**Joint Response of
Cherwell District Council
and
Oxfordshire County Council
to the Oxfordshire Strategic Rail Freight Interchange Stage 2
Consultation**

November 2025

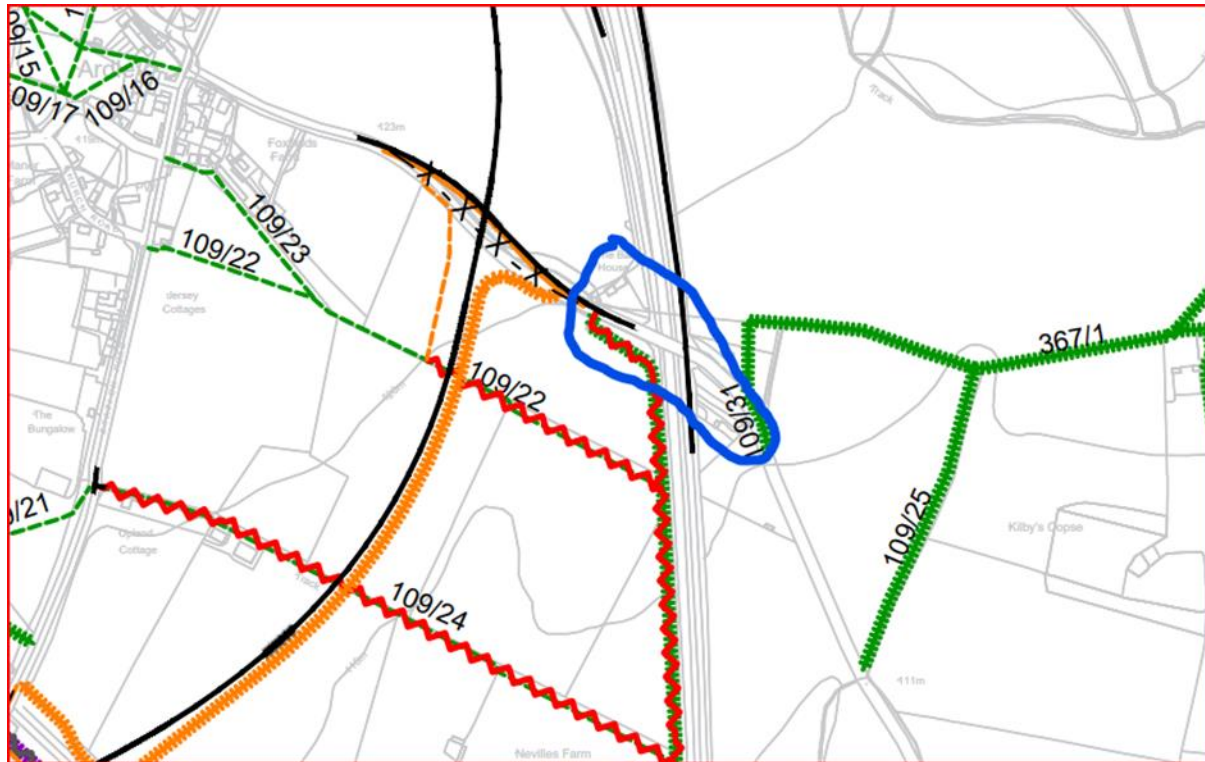
- 8.2.26 Cycle and pedestrian access is shown in the Walking, Cycling and Rights of Way Strategy Plan and provides an off-carriageway link to Ardley as part of the main access junction/Ardley bypass works. An off-carriageway cycle link would connect the site at its southern end to works to be provided by the current permissions at Heyford Park in Phase 1, and a cycle route along the site frontage on the B430 would be provided.
